#### Eighty-third session

Geneva, 1–4 June 2021

## Report of the Working Party on Pollution and Energy (GRPE) on its eighty-third session

Figure 1  
NEDC test cycle

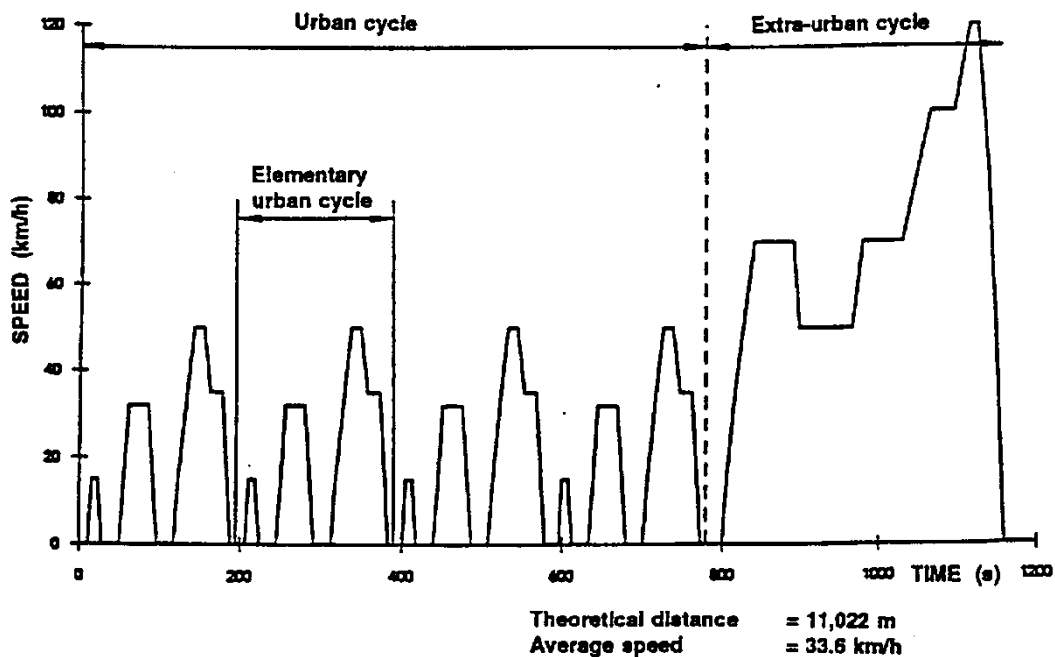
- ~~“2.1. NEDC test cycle Test sequence~~
- ~~2.1.1.1. Composition~~
- The NEDC test cycle test sequence is composed of two parts (see Figure 1):

Figure 3a  
Shortened NEDC test sequence

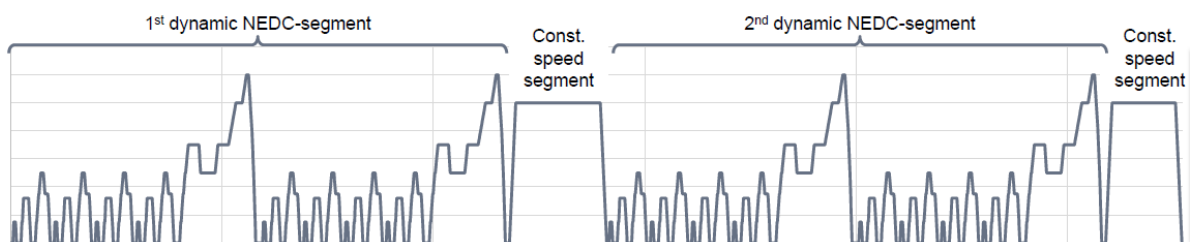
The shortened NEDC test sequence consists of two dynamic NEDC-segments (DS<sub>1</sub> and DS<sub>2</sub>) combined with two constant speed segments (CSS<sub>M</sub> and CSS<sub>E</sub>) as shown in the following figure.

The dynamic NEDC segments DS<sub>1</sub> and DS<sub>2</sub> are used to calculate the electric energy consumption. The constant speed segments CSS<sub>M</sub> and CSS<sub>E</sub> are intended to reduce test duration by depleting the REESS more rapidly than driving consecutively NEDC test cycles.

Figure 12

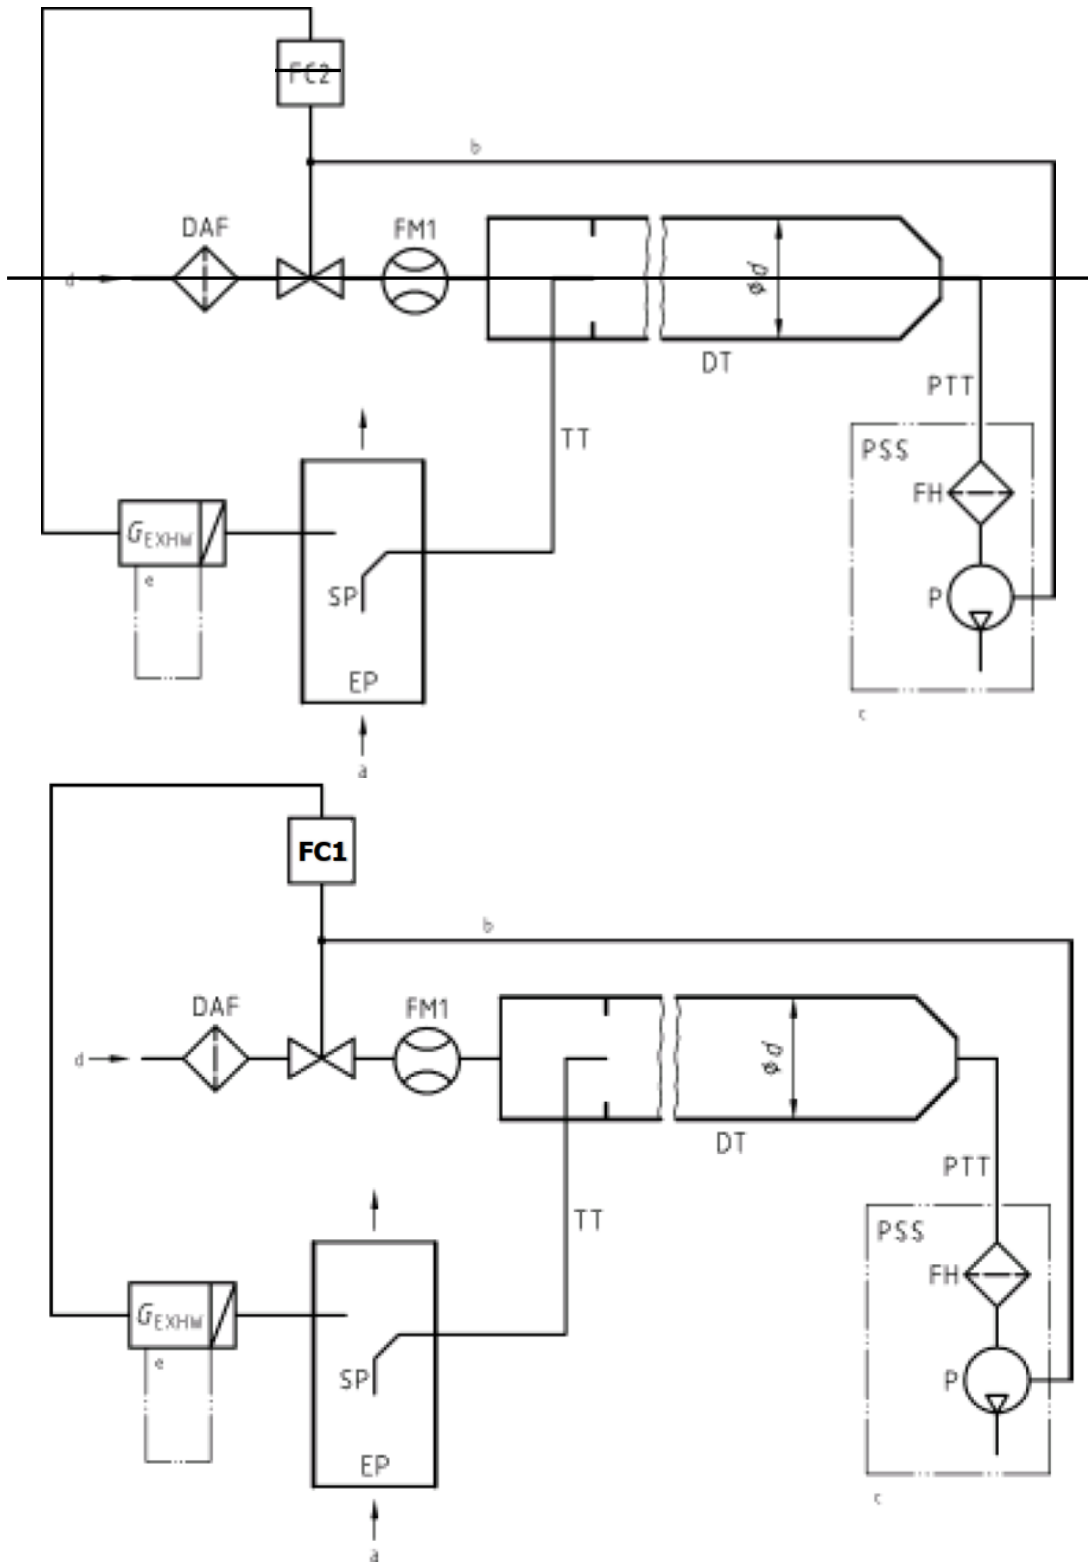
In the text, the flow controller is represented by "FC1", whereas in Figure 12, it is "FC2". Therefore, it is necessary to correctly set "FC1" in Figure 12.

a = exhaust      b = optional      c = details see Figure 16  
 ..."
